**TWO-PIECE OIL CONTROL RING  
ELECTRA-GLIDE AND SPORTSTER MODELS**

HARLEY-DAVIDSON MOTOR CO.

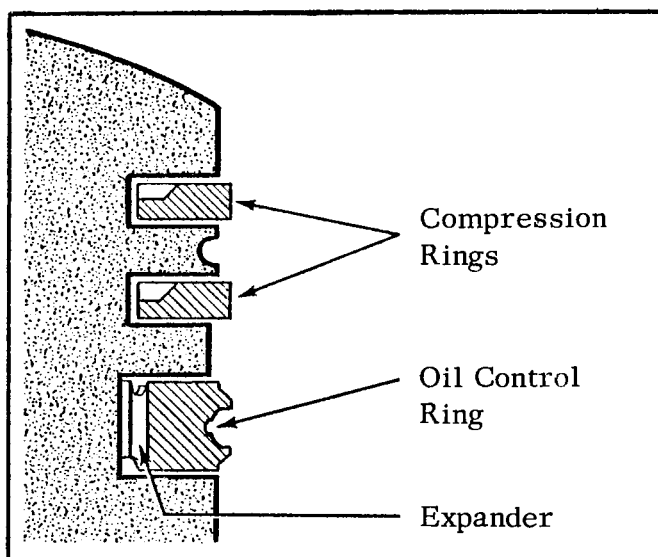
A two-piece oil control ring has been in use on the Sportster and Electra-Glide engine since the start of the 1966 model season.

This ring for the lower piston ring groove consists of a ventilated cast iron double edged scraper ring with a separate expander spring behind it.

The new two-piece oil ring is now included in all standard and oversize piston ring sets and piston assemblies supplied for parts orders.

Rail type oil control rings will no longer be supplied.
